Groundwater Application Review Summary Form

Application # G18924	
GW Reviewer Phil Marcy Date Review Comple	eted:04/01/2020
Summary of GW Availability and Injury Review:	
[] Groundwater for the proposed use is either over ap amounts requested without injury to prior water rights capacity of the groundwater resource per Section B of	, OR will not likely be available within the
Summary of Potential for Substantial Interference Rev	view:
[] There is the potential for substantial interference p	er Section C of the attached review form.
Summary of Well Construction Assessment:	
[] The well does not appear to meet current well cons review form. Route through Well Construction and Co	
This is only a summary. Documentation is attached an	d should be read thoroughly to understand the
basis for determinations and for conditions that may be	e necessary for a permit (if one is issued).

Review of Water Right Application G-18924

Water-Level Trends in Nearby Wells

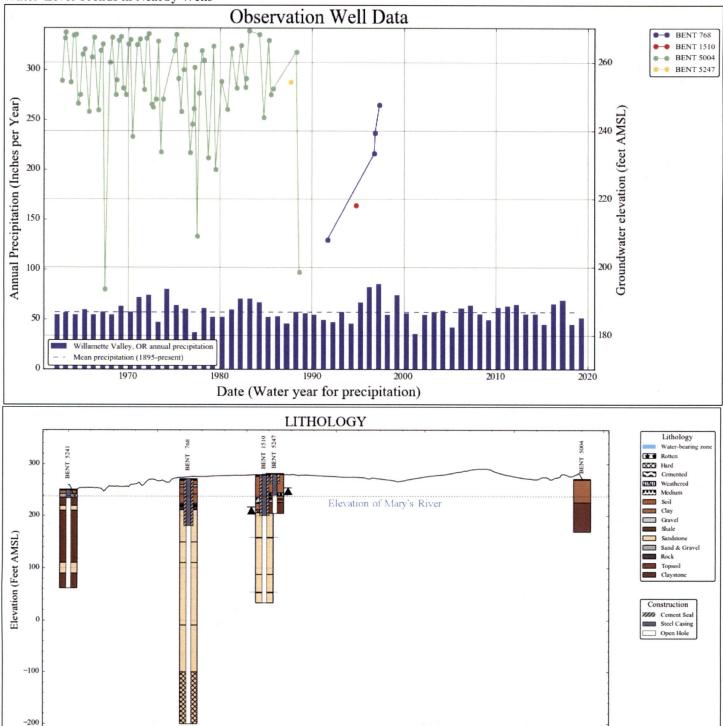
Cross-section illustrates the correspondence of water-bearing gravels and head elevation of POA well 1 (BENT 5247) with the nearby Marys River. POA well 2 (BENT 1510) produces from discrete portions of the Spencer Formation sandstone, with resulting head elevations much lower. Cross-section well locations displayed on attached map.
